November 4, 1994

Enclosed are revisions and additions to the Maryland Department of the Environment, Waste Management Administration's comments (dated September 30, 1994) from technical review of the report entitled "Draft Focused Remedial Investigation Report of the Galaxy/Spectron Site", dated May 4, 1994.

MARYLAND DEPARTMENT OF THE ENVIRONMENT  
WASTE MANAGEMENT ADMINISTRATION  
Comments on the Draft Focused Remedial Investigation  
Report, Galaxy/Spectron Site  
Cecil County, Maryland

# MDE Figure 1. Fracture Intensity of Angled Wells (MDE Interpretation)

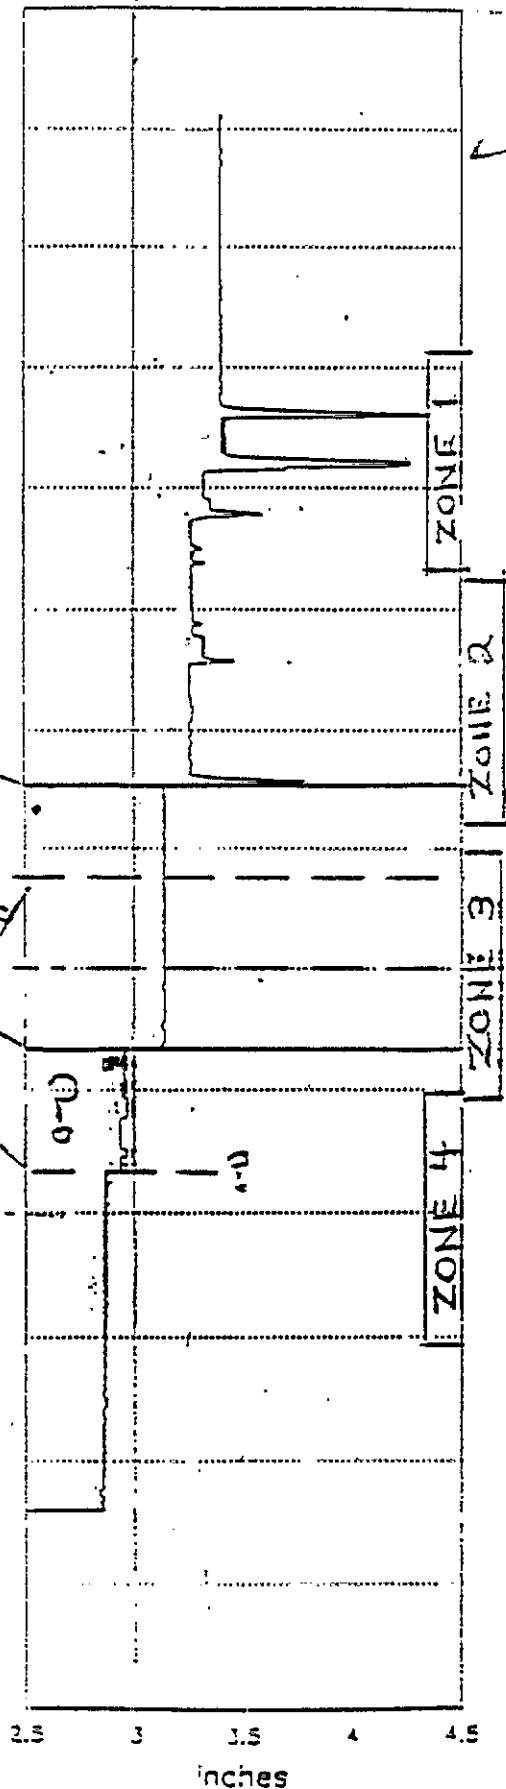
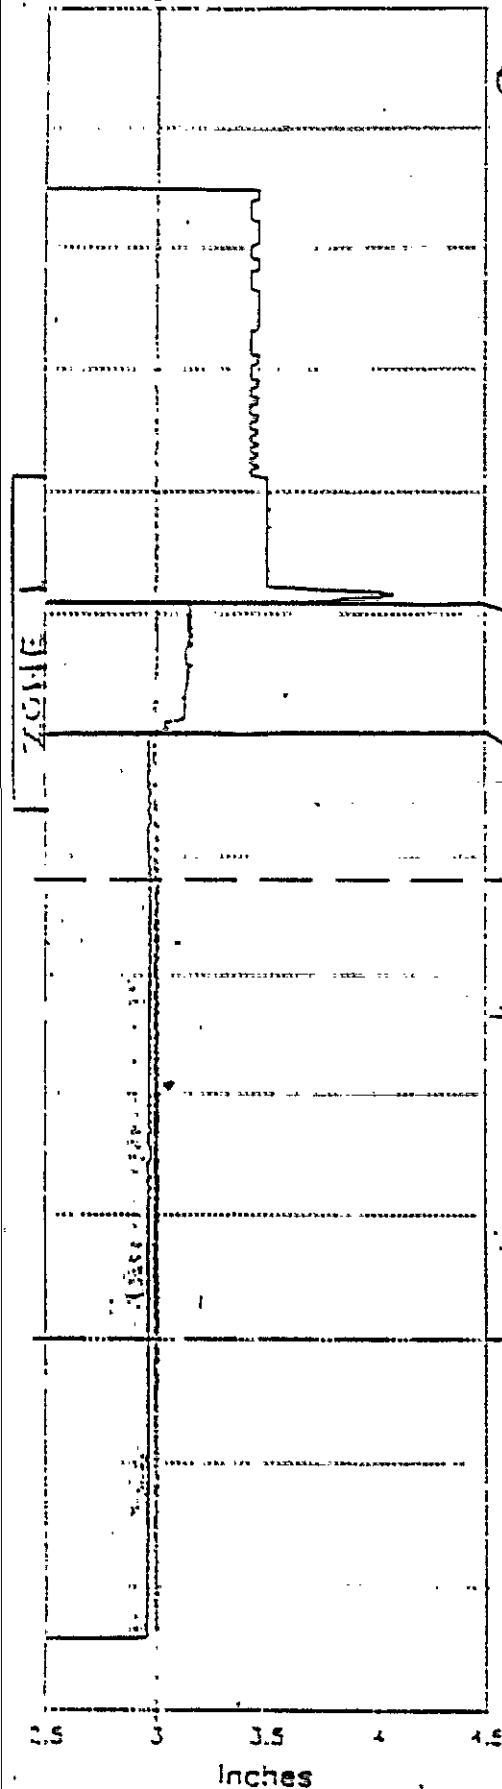
Highly Fractured - 0 to 49 feet  
 Moderately Fractured - 49 to 60 feet  
 Slightly Fractured - 60 to 140 feet

Highly Fractured - 0 to 64 feet  
 Moderately Fractured - 64 to 86 feet  
 Slightly Fractured - 86 to 140 feet

Differentiation into these zones is based upon borehole diameter, rugosity of the borehole wall, and the size and frequency of borehole washout areas (large fractures) as indicated on the caliper and normal resistivity logs (Figures 2-8 and 2-9). We do not believe it is appropriate to base fracture density solely on the basis of visible breaks in the cores. The effective fracture frequency is more accurately measured from the in-place aquifer parameters rather than visual inspection of cores exclusively. Many breaks within these cores are caused by stress during the coring process and are not present in the subsurface. Other criteria for conductive fractures should be present to distinguish physical breaks caused by the coring process from actual conductive fractures which are present in the subsurface. The borehole geophysical log response is the most accurate data source available to quantify these fractures and distinguish them from fractures induced solely by the core drilling process.

- 45) Groundwater concentrations of total volatile organic contaminants from packer tested intervals in the angled bedrock wells (Table 4-7) match very closely with the proposed fracture intensity zones in MDE comment #14 (See MDE Figure 1). When the total VOC concentrations in these wells are plotted on the caliper logs, there is a very good correlation of high VOC levels with these geophysically defined fracture intensity zones. The enclosed MDE Figure 3 illustrates these relationships. It was fortuitous that the sampled intervals correspond relatively well with the proposed fracture intensity zonations in these wells. A dramatic difference in groundwater contamination levels is present between the slightly fractured and the moderately fractured portions of each of these wells. Little or no significant difference in contamination levels is apparent, however, between the highly fractured and moderately fractured portions of these boreholes. The contaminant concentrations found within the slightly fractured bedrock intervals (up to 0.15% VOCs), confirms the likely presence of mobile DNAPL compounds in some fractures within these intervals. Because of decreased fracture intensity and decreased fracture aperture with depth, it is likely that most, if not all, mobile DNAPL is trapped in the marginally fractured parts of the bedrock in a dynamic equilibrium state. Although vertical migration deeper into the slightly fractured bedrock is unlikely, there is still the possibility of lateral migration into the moderately to highly fractured portions of bedrock fracture zones. MDE Figure 4 illustrates the potential for lateral DNAPL migration from the slightly fractured into the moderate to highly fractured portions of the bedrock aquifer.

MDE Figure 2. Preferred Cross-Hole Testing Program  
For Possible Future Tests.

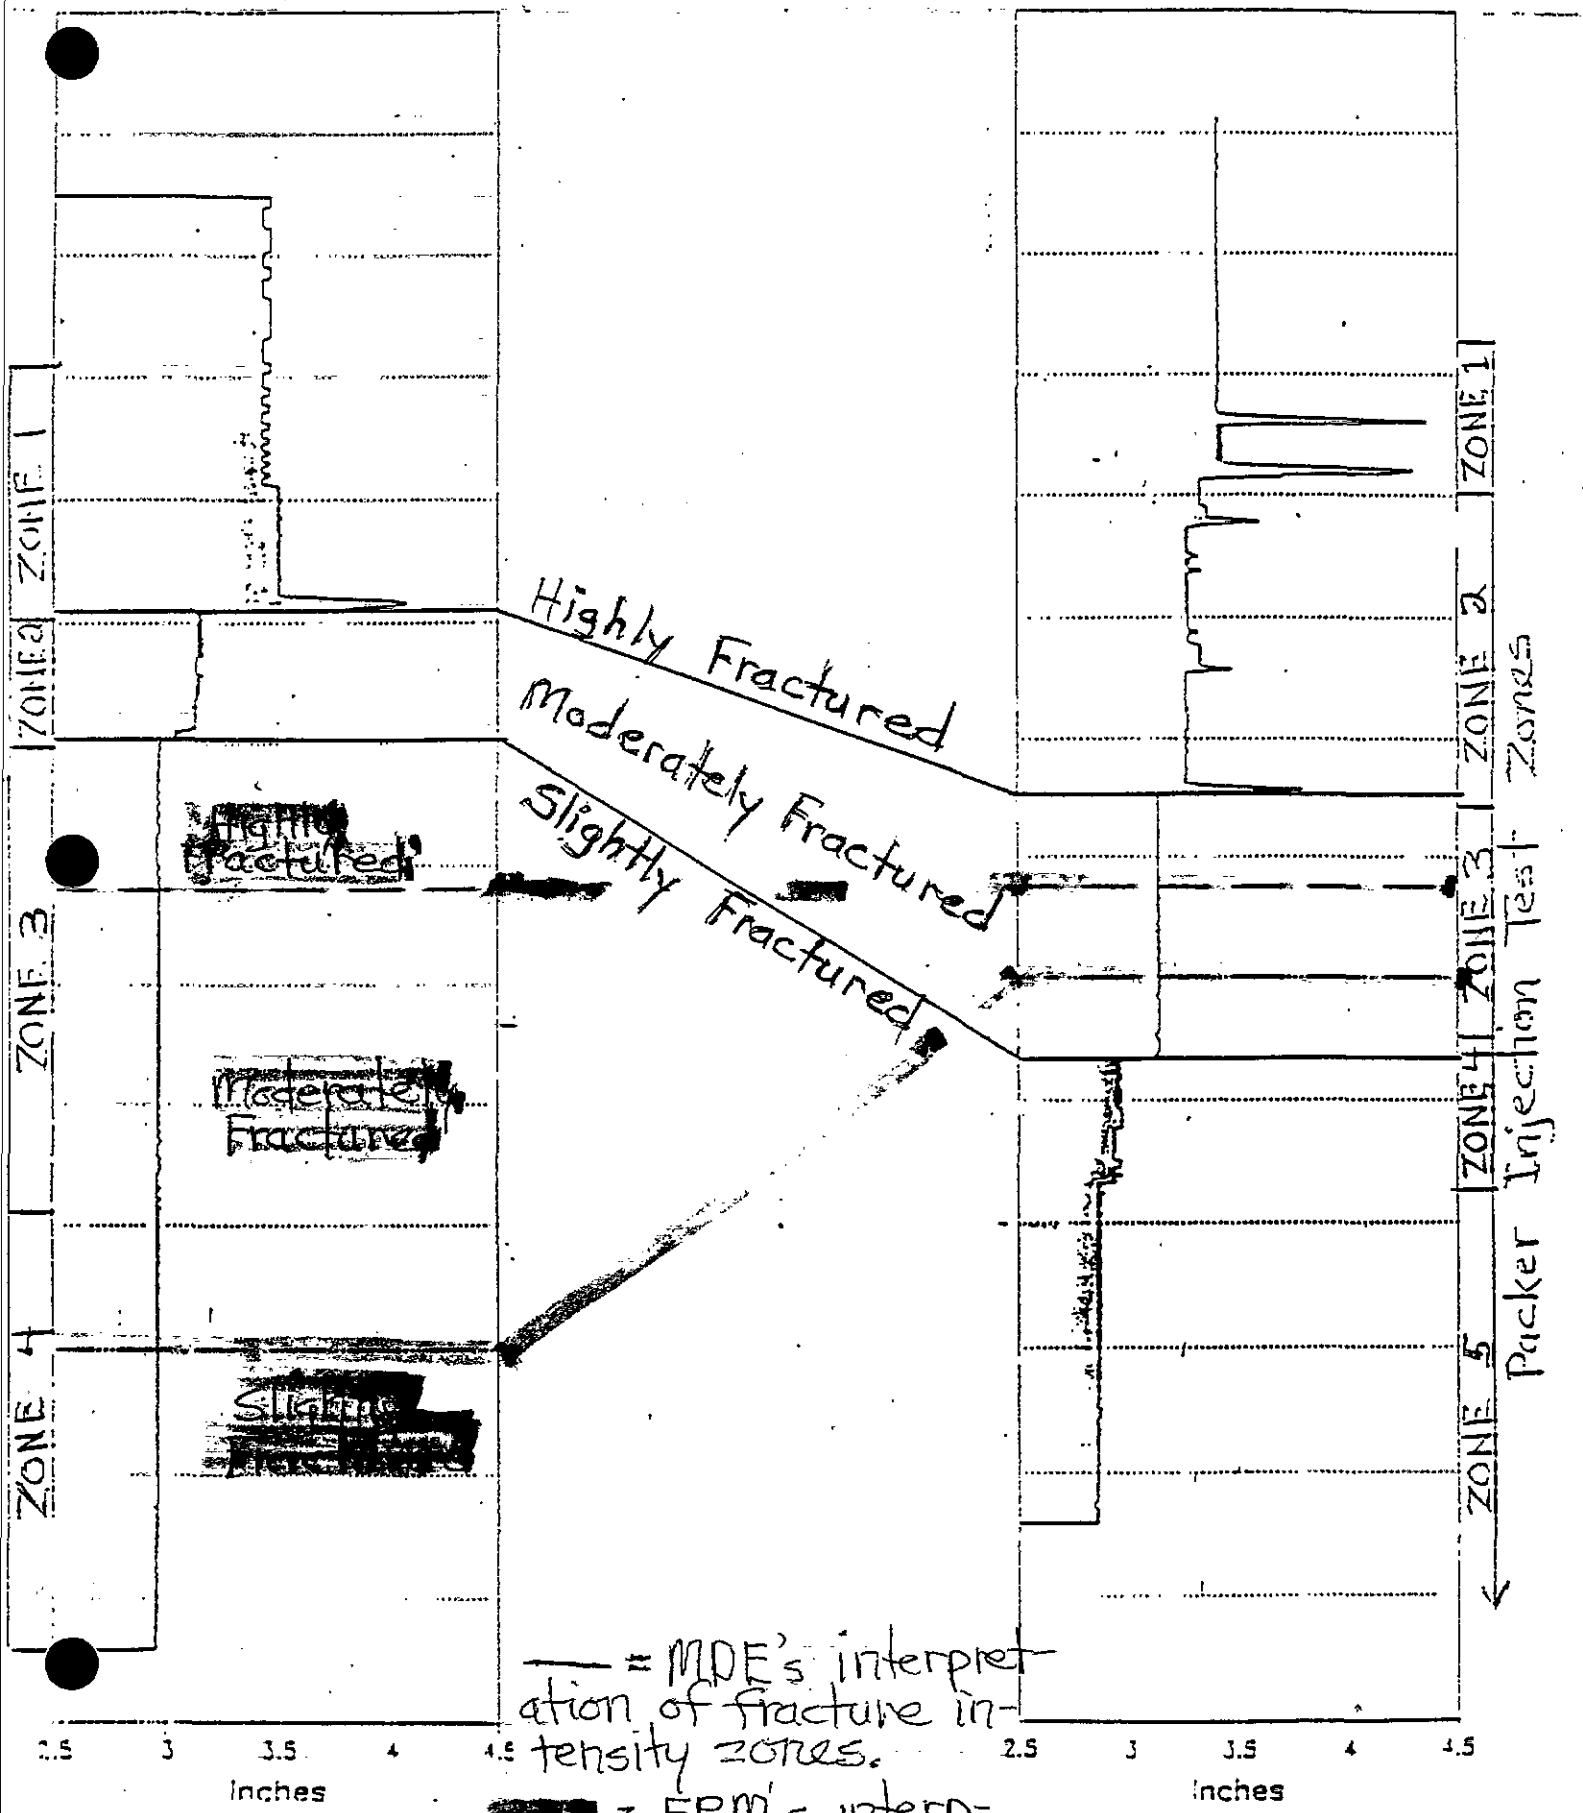
In MDE comment #14, it is suggested that the angled wells be divided into zones of varying fracture intensity, based primarily on borehole geophysical log response (highly fractured, moderately fractured and slightly fractured). It should be noted that cross-hole monitoring zone #1 of AW-1 encompasses all three of the proposed fracture intensity zones defined in MDE comment #14 (See enclosed MDE Figure #1). If these proposed zones do, in fact, represent zones of relative fracture intensity and interconnection, then it should not be surprising that a response in AW-1, zone 1 might be detected from packer tests in all zones in AW-2. If future cross-hole testing is performed in these wells, the test intervals and monitoring intervals should be set up so that a more unique interpretation of potential zones of communication can be made (see enclosed MDE Figure #2).

MDE Figure 3. Ground Water Contamination Levels In The Angled Wells (From Table 4-7).

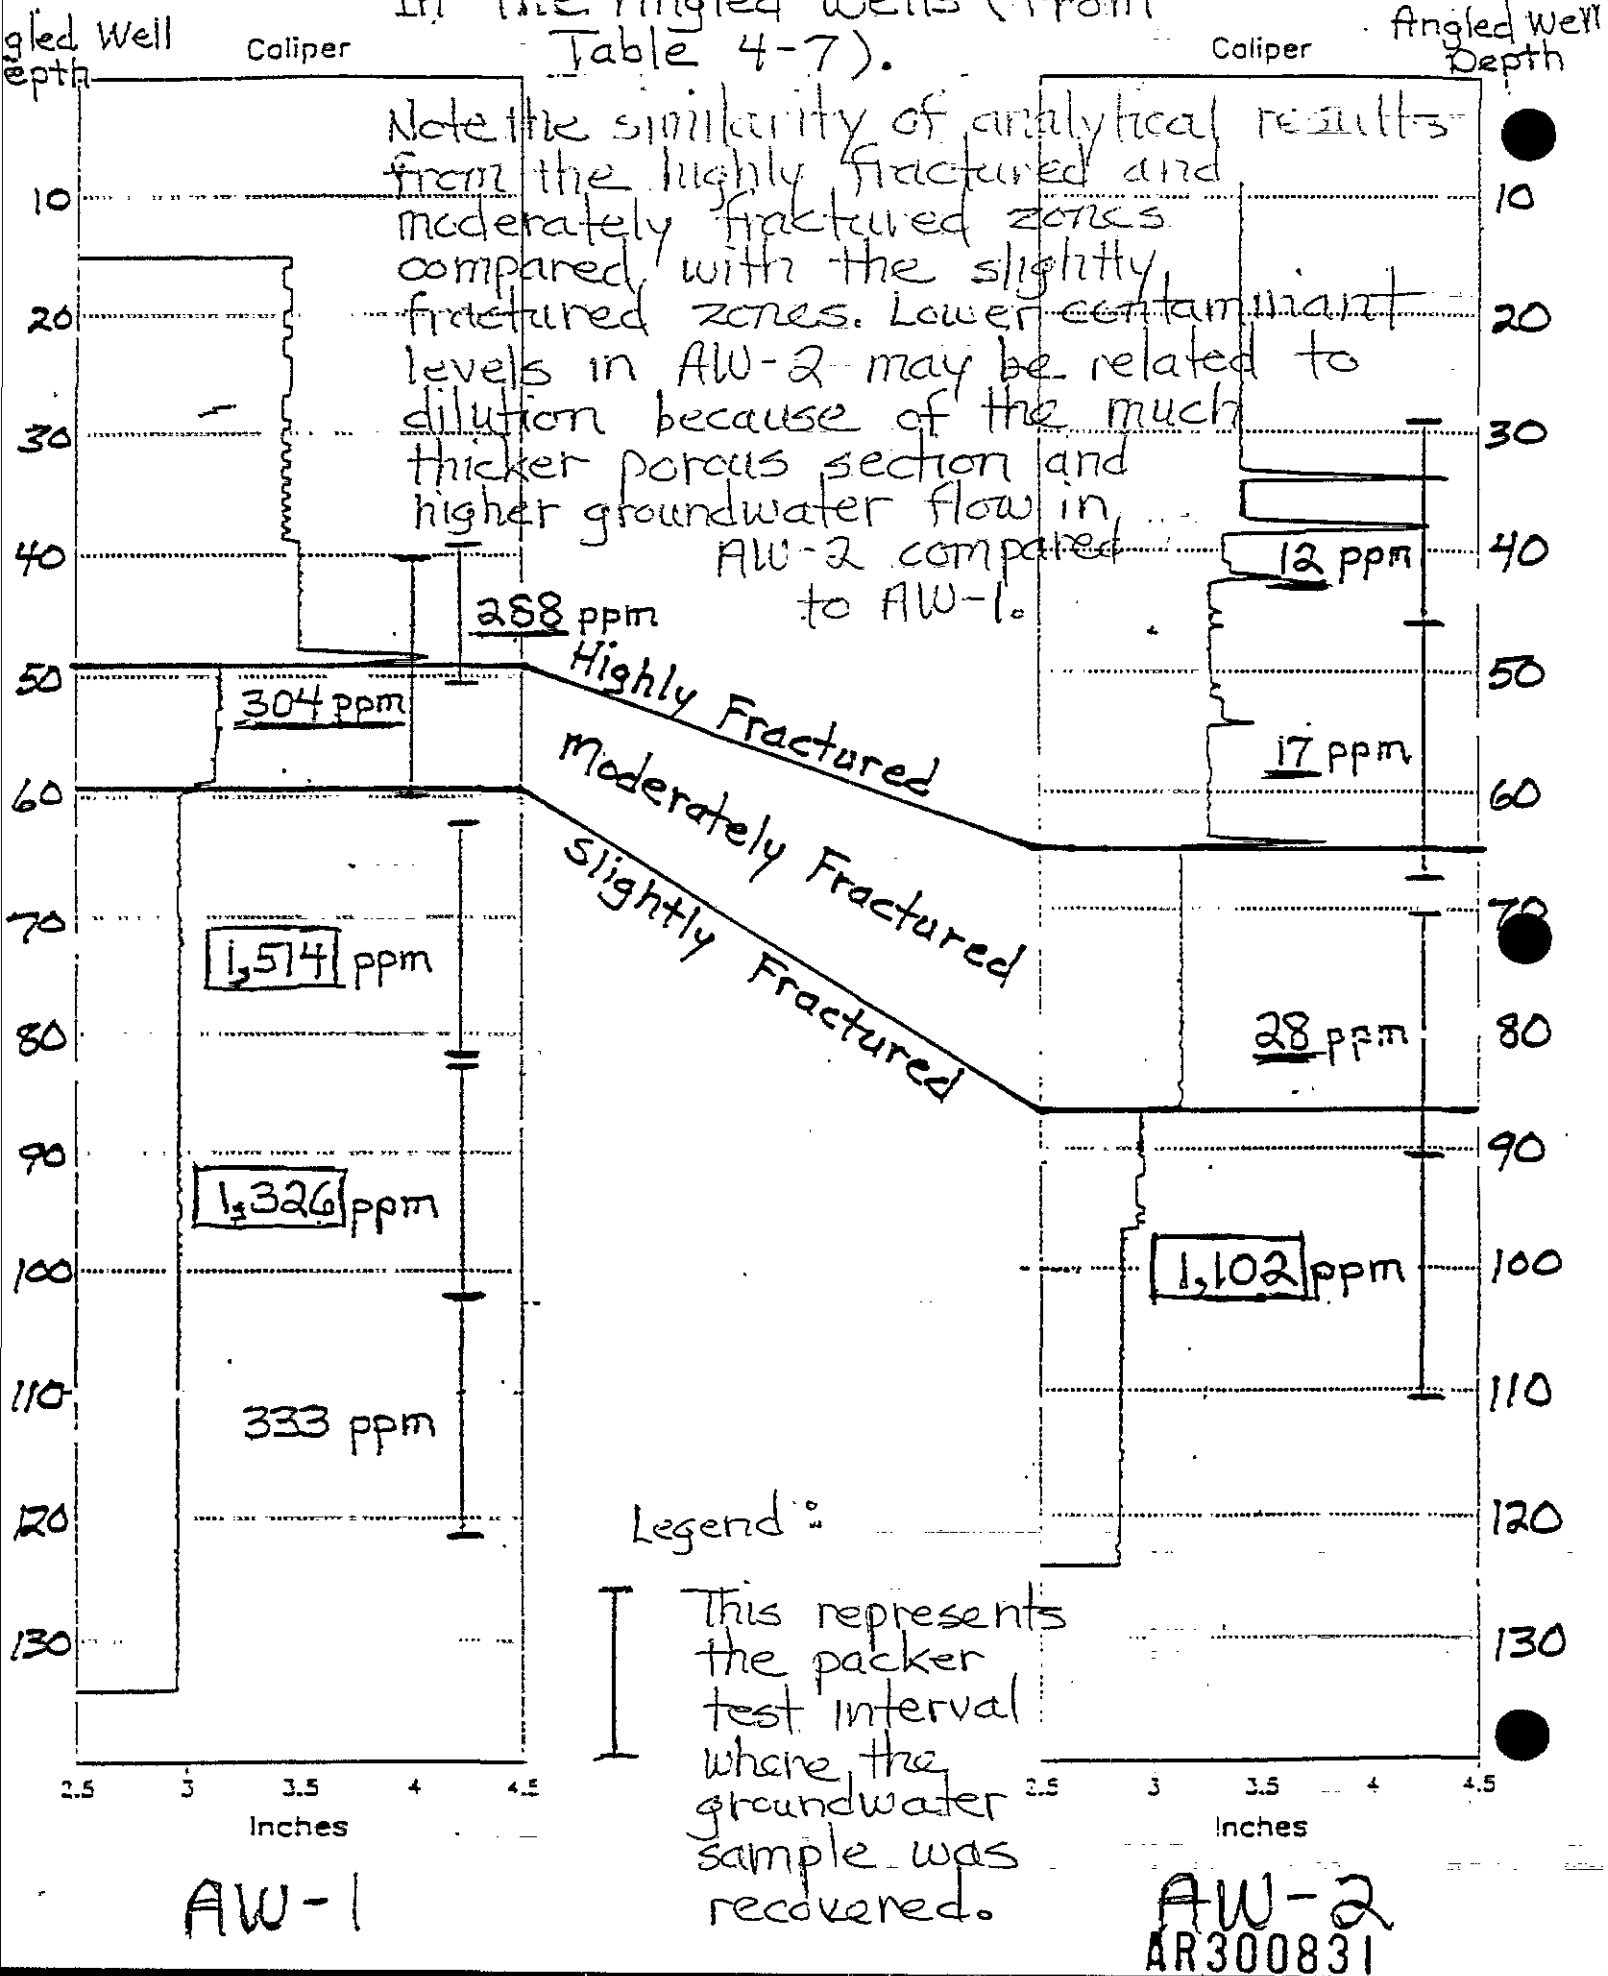
The distribution of contaminant concentrations in the bedrock aquifer (as exemplified by AW-1 and AW-2) appear to coincide with petrophysical properties of the aquifer (degree of weathering, fracture density, fracture interconnection, porosity, etc. - See Maryland Department of the Environment [MDE] Figure 3.) These petrophysical properties can be qualitatively measured as discrete zones of varying thickness by the appropriate geophysical methods which respond to these properties (borehole geophysics and various seismic borehole imaging techniques). The petrophysical properties observed in the borehole can be extrapolated three-dimensionally away from the borehole by such techniques as vertical seismic profiling, cross-hole and surface to borehole seismic tomography, cross-hole packer testing, azimuthal electrical resistivity surveys, etc. Once the three-dimensional aspects of bedrock petrophysical properties have been established in the specific test area (e.g. in the vicinity of AW-1 and AW-2), the petrophysical properties of interest can be extrapolated as subsurface trends with appropriate geophysical surveys.
